**SUZUKI**  
**2-Stroke**  
**Service Bulletin**  
**Index**

Bulletin No: RM-1

Subject: RM125 SPECIFICATIONS

Subject: RM125 CHAIN GUIDE ROLLER WASHERS

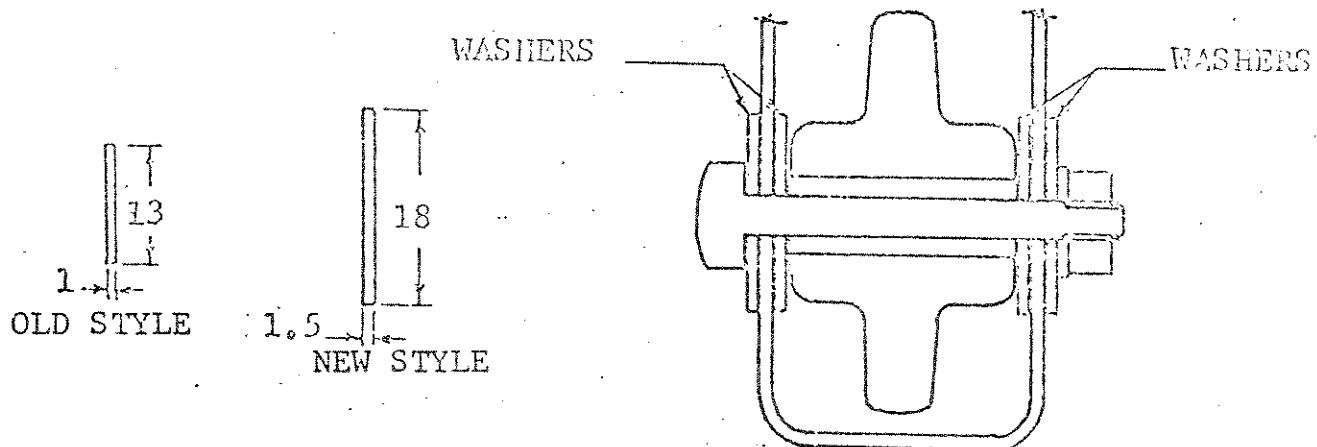
The washers on each side of the rear chain guide roller are too small. Under hard usage they may bend and bind the roller causing the roller to be damaged by the chain.

The thickness and outside diameter of the washers have been increased for improved durability.

The new washers are installed on all RM125's from F/No. - 16174.

Please change to the new style washers on any units you have received manufactured before the above numbers.

Subject: MIS-ENGAGEMENT OF RM125 3RD GEAR

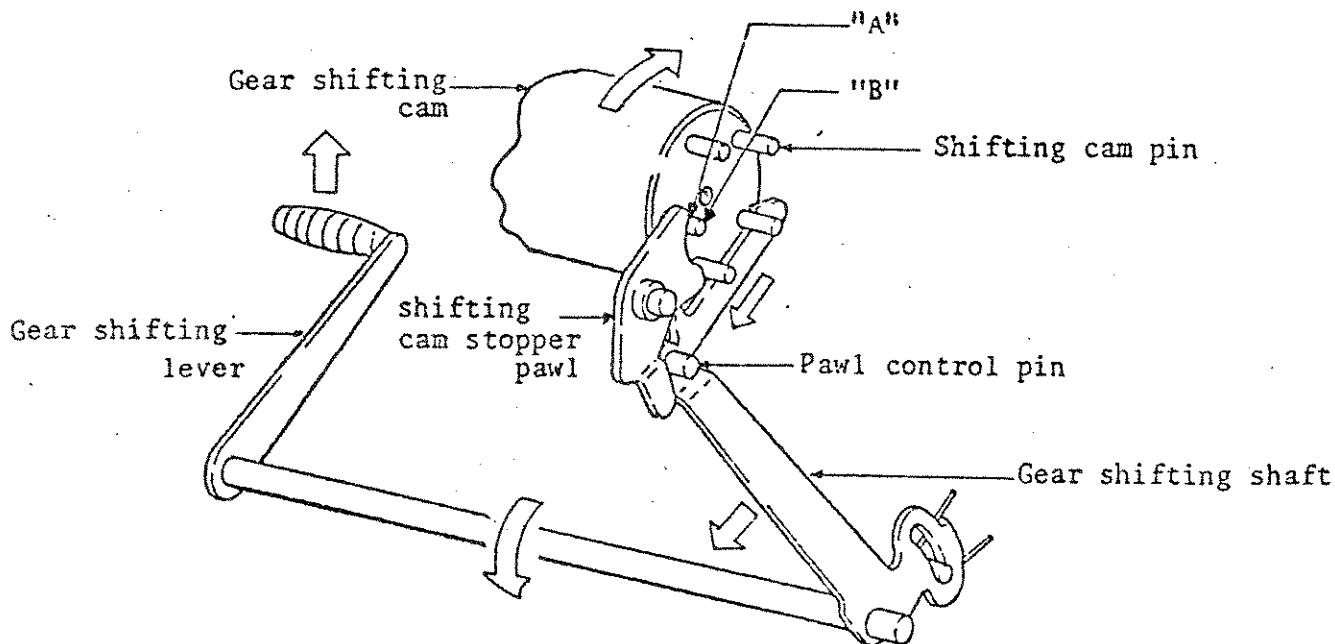
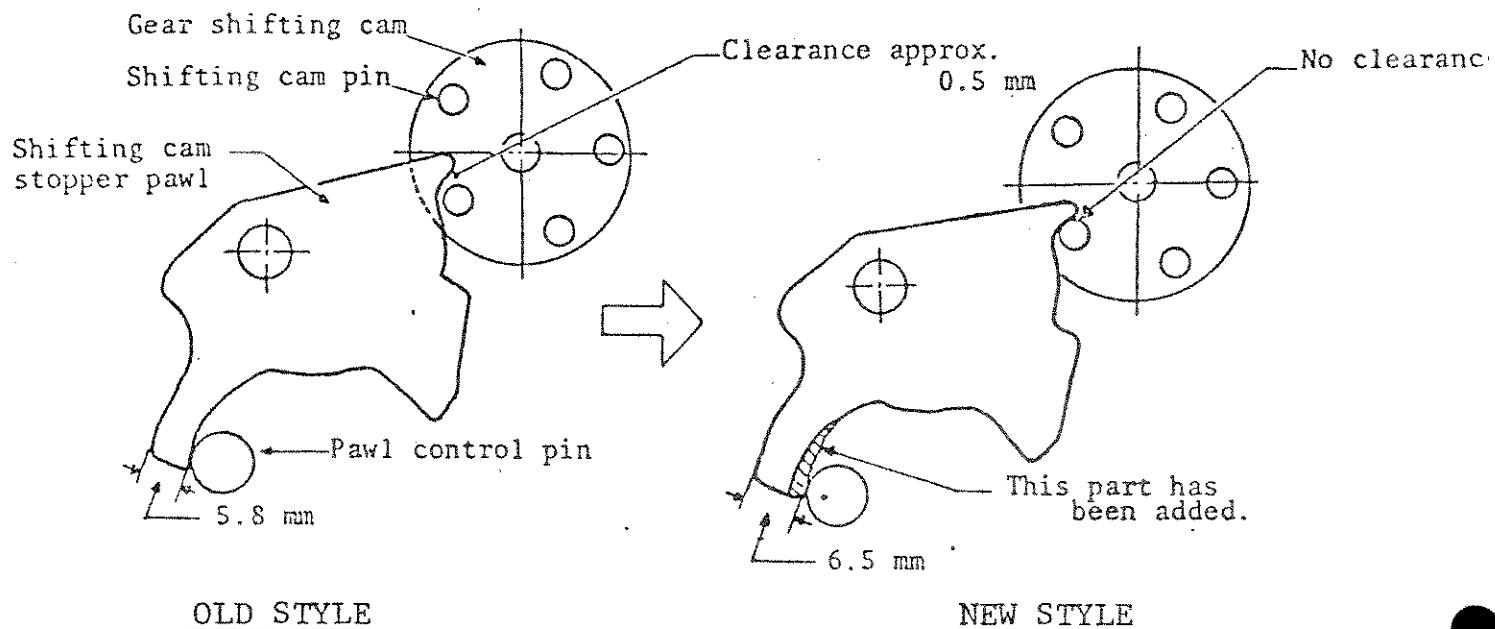
During prolonged and severe competition usage, some RM125's may experience overshifting from 2nd to 3rd gear. This results in a false neutral between 3rd and 4th gear.

The amount of shift cam rotation is limited by contact of the shifting cam stopper pawl "A" and shifting cam pin "B". If the shifting cam stopper pawl becomes excessively worn at the shift cam pin contact area, over shifting can occur. This is because the shift cam is then allowed to rotate past 3rd gear.

The shifting cam stopper pawl has been dimensionally changed as shown below:

This change removes all initial clearance at the shift cam pin contact area.

The new style shifting cam stopper pawl is now available from U. S. Suzuki's Parts Department. The old and new style parts are interchangeable. The new style part number is 25370-12101.

The new style shifting cam stopper pawl has been installed on and after Engine Number RM125-16201.

Subject: RM250/RM370 REAR FUEL TANK CUSHION  
MODIFICATION

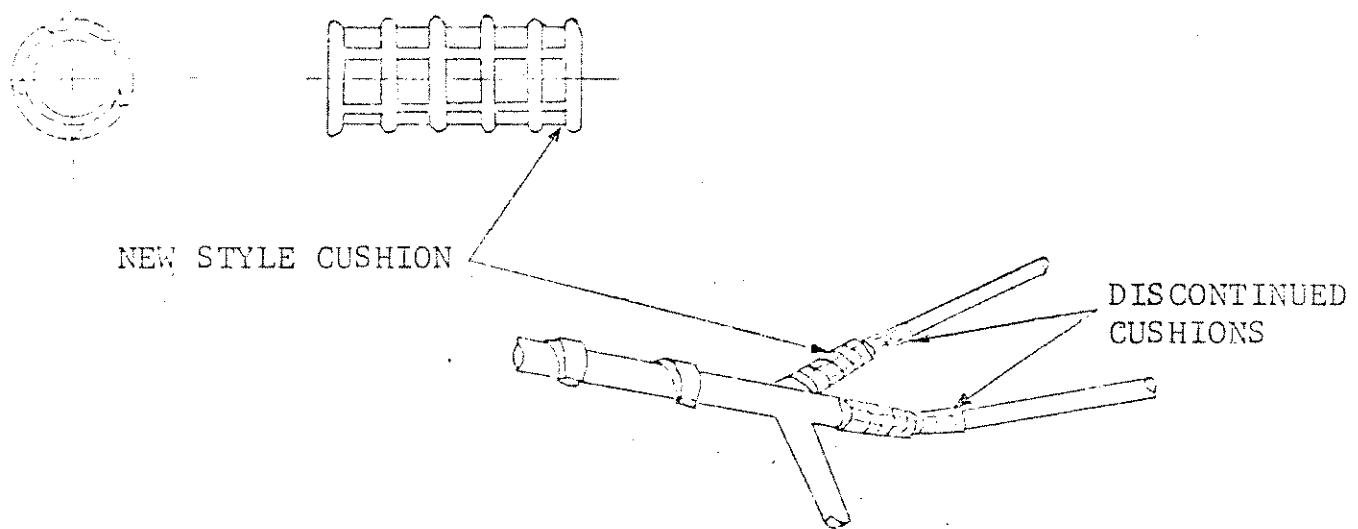
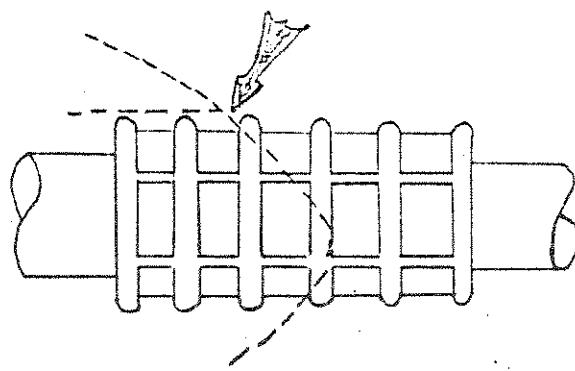
We have received information that RM250 aluminum alloy fuel tanks may become unnecessarily worn at their inner rear portion. This has been found to be caused by allowing the rear fuel tank cushion to become excessively worn.

RM250's on and from Frame Number 11122 have had the use of the most rearward fuel tank cushions discontinued. At the same time, the "new" most rearward cushions (44511-15201) have had their dimensions increased and five horizontal ribs added.

1. The fuel tank cushions should be checked after each race and replaced if worn. Regular replacement of these cushions will prevent unnecessary wearing of the RM alloy fuel tank.

2. Attach new fuel tank cushions to the frame with an epoxy or adhesive cement.
3. Also, when attaching new cushions, position them so that the rear of the fuel tank contacts the third vertical rib as shown below:

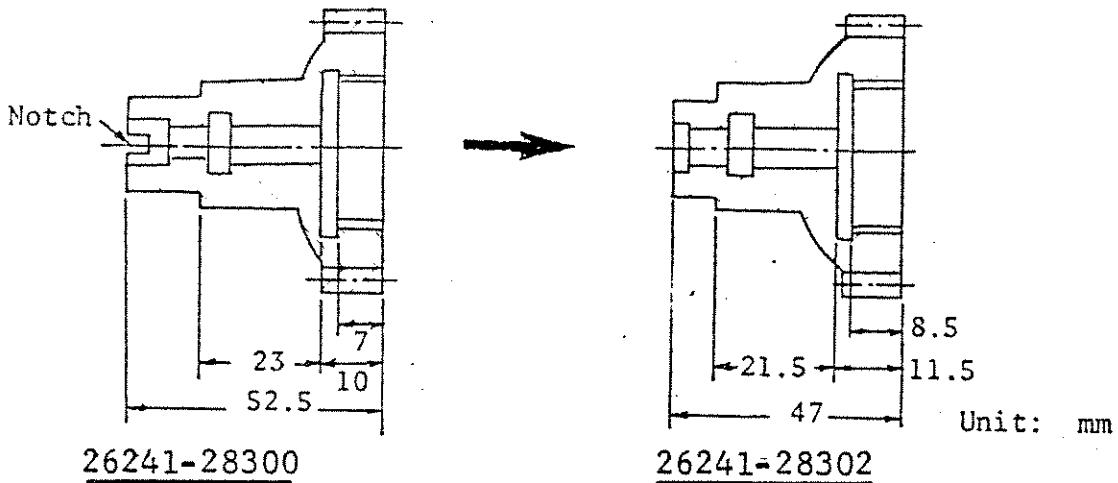
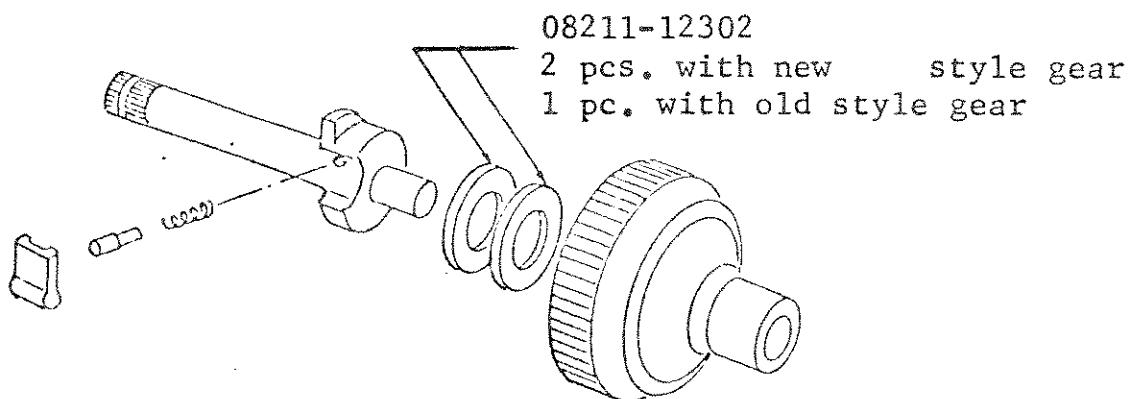
To increase it's durability, the RM125 kick starter drive gear pawl contact surface has been widened 1.5mm. At the same time, a 1.5mm thrust washer has been added to the existing one. Also, the oil pump drive notch has been eliminated, shortening the overall length of the gear.

The old and new style kick starter drive gears are interchangeable. When replacing an old style kick starter drive gear with a new style, be sure to use two thrust washers (08211-12302) inside the

## CYLINDER PORT CHAMFER:

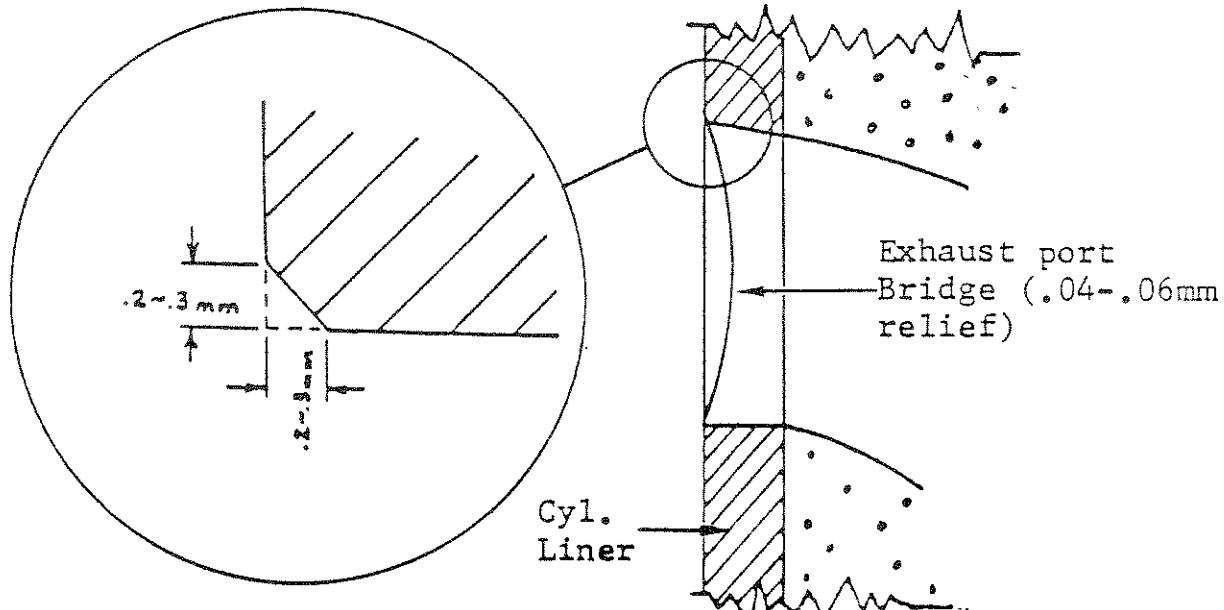
Whenever inspecting an RM250 or RM370's cylinder port chamfer, you will notice that the chamfer is very slight as compared to other Suzuki models. Both the vertical and horizontal dimensions of the chamfer should be .2-.3mm, as shown below:

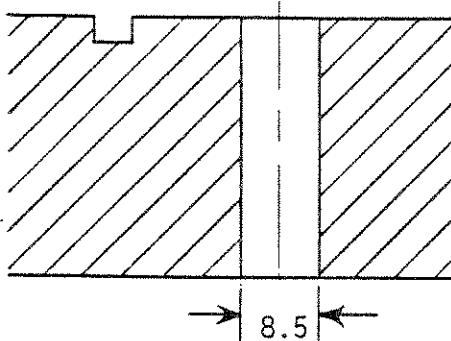
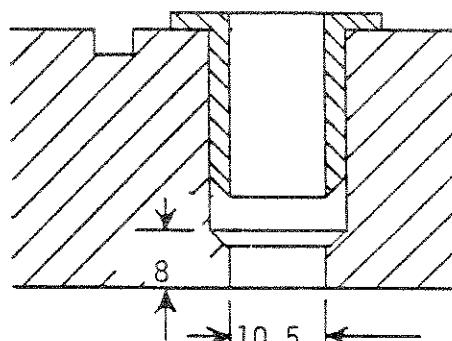
To protect RM250 and RM370's crankcases against damage resulting from lack of proper torque applied to engine mounting bolts, bushings have been added to the engine crankcases.

B. As of Frame Number RM250-12173 through 13750 a bushing was added to the upper rear crankcase engine mount only. The dimensions of the bushing are illustrated below.

C. As of Frame Number RM250-13751 and after, the upper rear engine mounting bolt's size was changed to 10mm. The size of the bushing was also increased to accept the new bolt as illustrated below.

The frame was also modified to accept the larger diameter bolt.

## II. RM370 (Upper and lower rear engine mount)

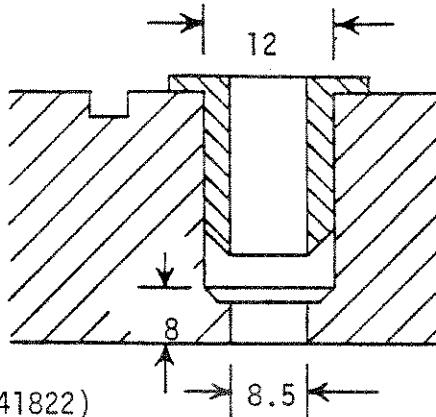
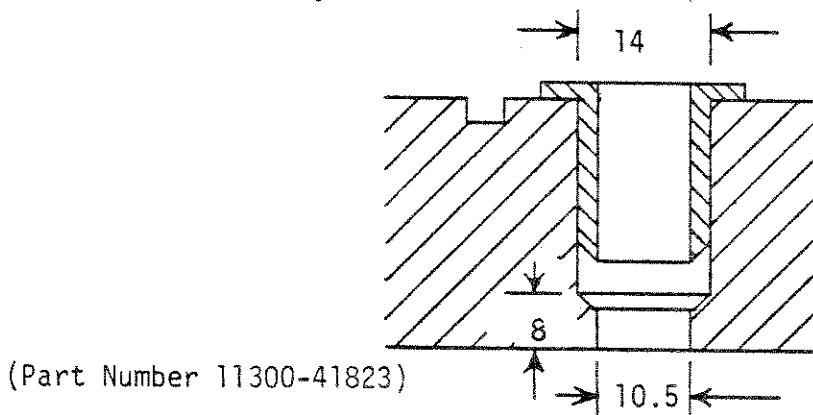
A. RM370's from initial production through Frame Number 13708, had both an upper and lower rear engine mount bushing installed. They are illustrated below.

B. As of Frame Number RM370-13109 the upper rear engine mount bolt's size was increased from 8mm to 10mm. The inside diameter of the upper rear engine mount bushing was increased to accept the larger engine mount bolt.

The frame was also modified to accept the larger diameter bolt.

RM250/370 MODIFIED AIR

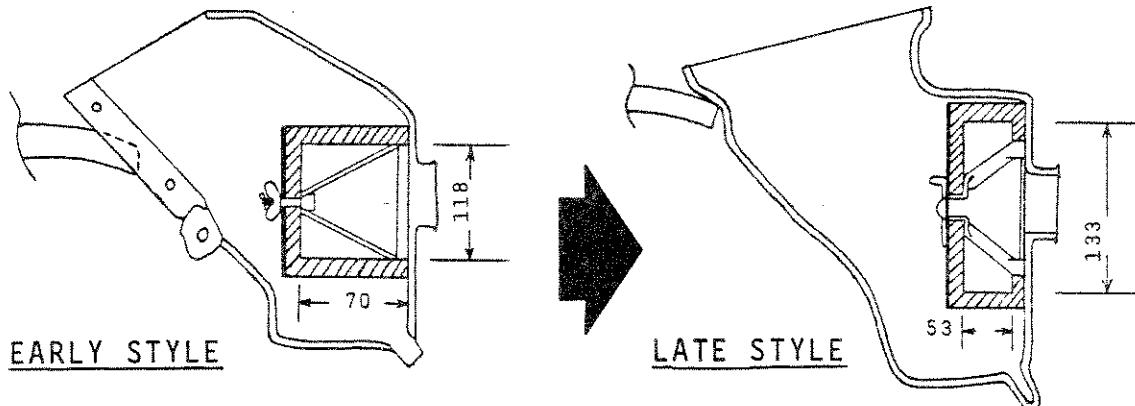
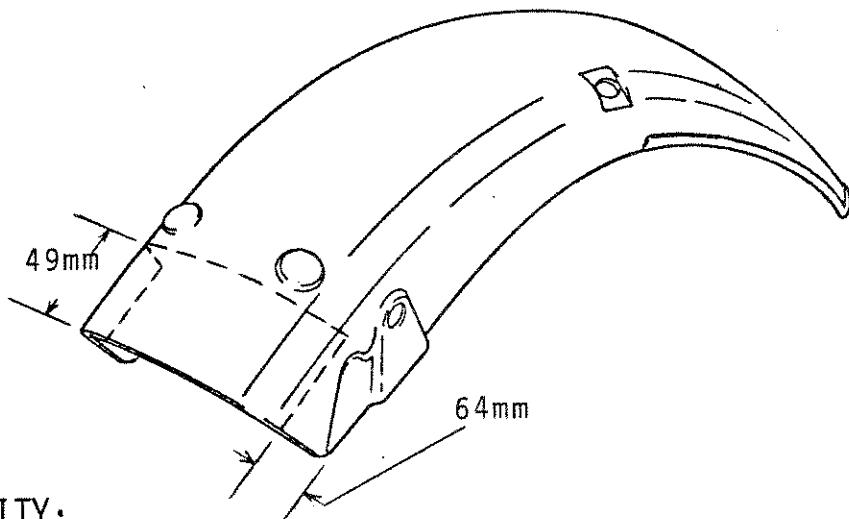
1. The shape of the air cleaner element has been changed to provide a more positive seal.
2. The shape of the air box has been changed to provide easier accessibility to the element.

3. To provide easier installation and removal of the filter element, the fastening device has been changed from a wing nut to a snap pin.
4. The carburetor air inlet hose mounting surface dimensions have been changed for more positive sealing, however, it's overall length remains the same.

\*The new style air cleaner assembly and individual components are now available from U.S. Suzuki's Parts Department.

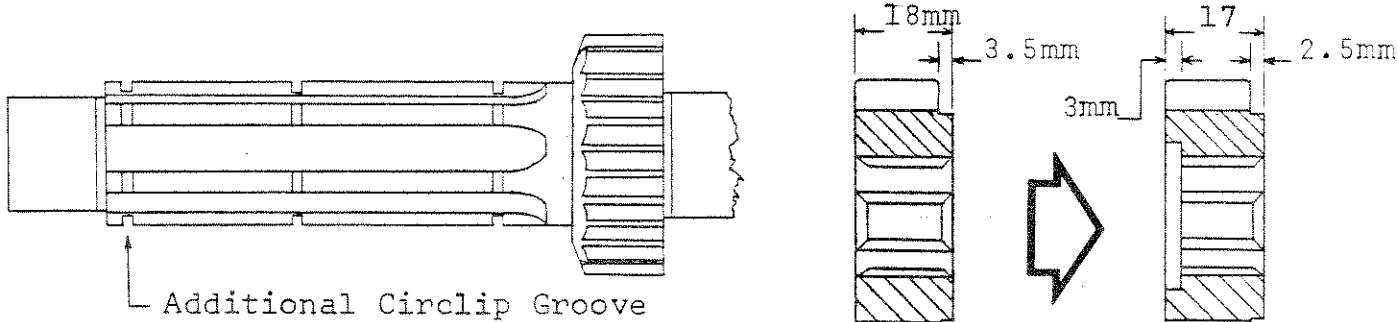
The countershaft and second drive gear have been modified in the manner illustrated below.

RM370's on and after ENGINE NUMBER-13644 will have the modified components installed.

RM-32

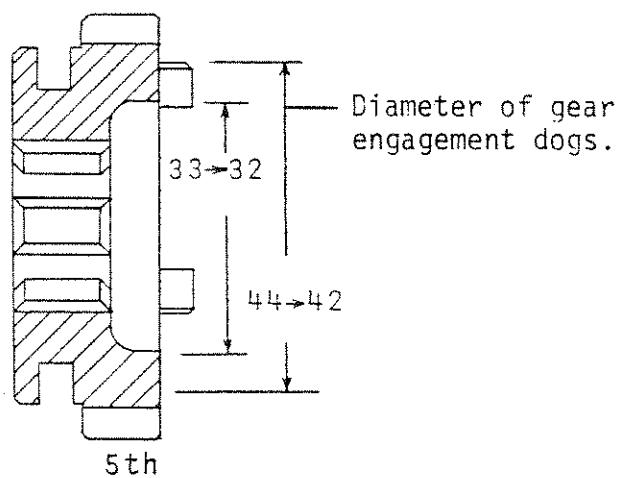
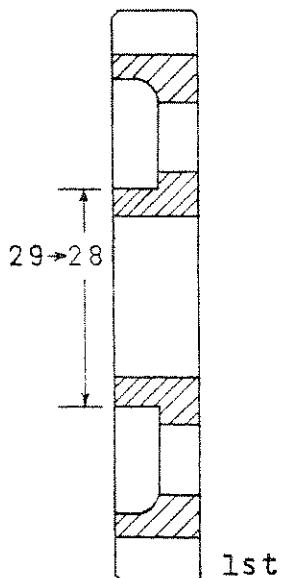
1st and 5th driven gears of the RM250 transmission have been changed to provide added strength and reliability. Although the actual gears ratios remain the same, certain structural dimensions have been changed as illustrated below.

RM250's on and after Engine Number 13800 have the modified driven gears installed.

**RM80 GEARSHIFT  
PAWL MODIFICATION**

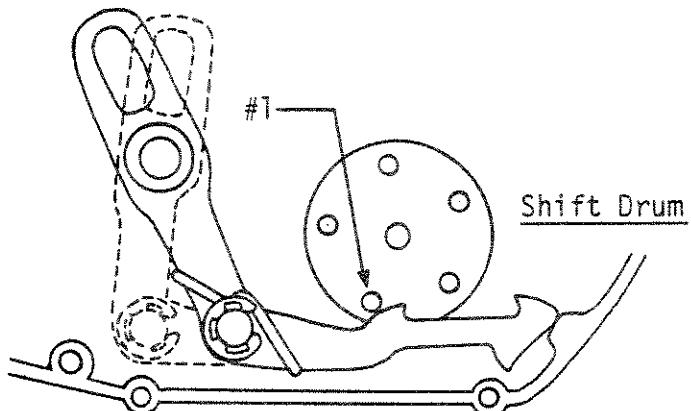
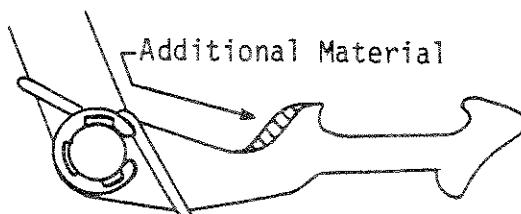
We have had reports of RM80's gear shift lever sticking in the up position, when shifting into higher gears; 3rd, 4th, or 5th. When this happens, the shift drum of the transmission is actually rotating past the normal stopping point, which allows the next shift drum pin (#1 in illustration) in rotation to restrict the shifting pawl's movement back to its original position.

This situation has been cured by the addition of a small amount of material applied to the gear shift pawl, which restricts the shift drum from rotating too far.

2. Second Style Tensioner

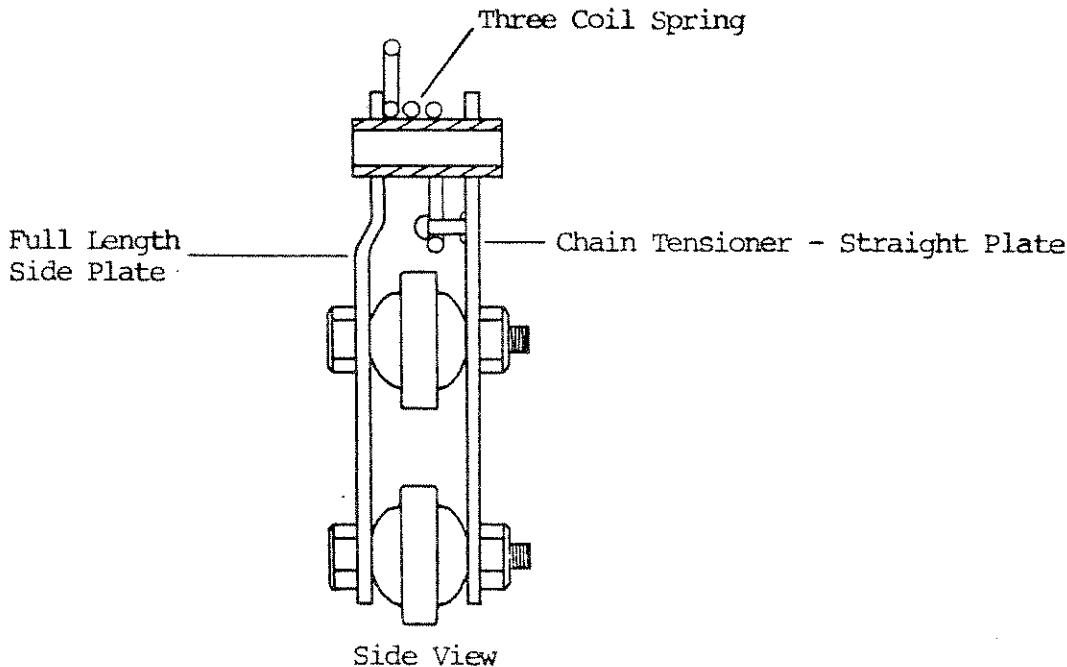
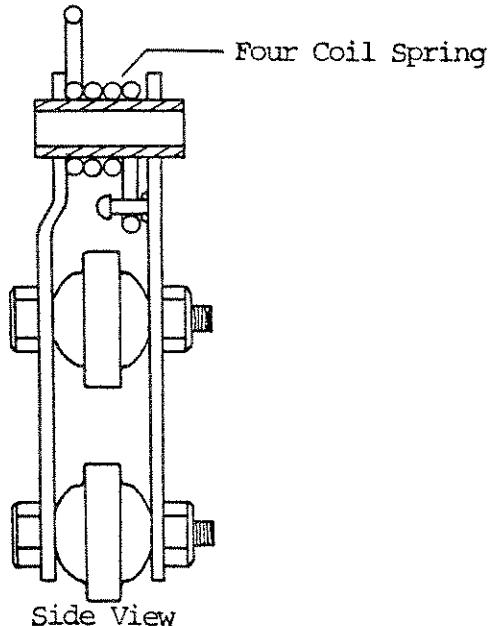
- a. The side plate was changed from 50mm in length to a full length plate.
- b. The chain tensioner's shape has been changed to a straight plate as illustrated above.

- a. The chain tensioner's spring was changed from a three coil style to a four coil style which increases spring tension. The remainder of the tensioner components remain the same.

RM125's having a Frame Number 51728 through 52687 have the second style components installed.

RM80 (OPTIONAL EQUIPMENT)

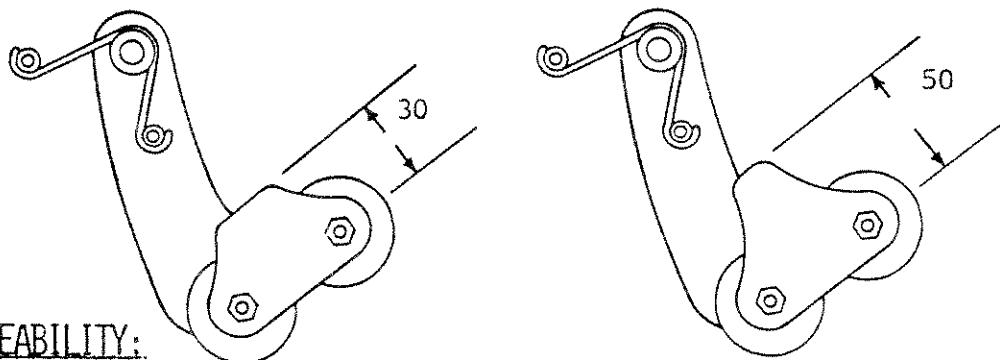
1. The RM80's chain tensioner has been modified by changing the original side plate as illustrated below.
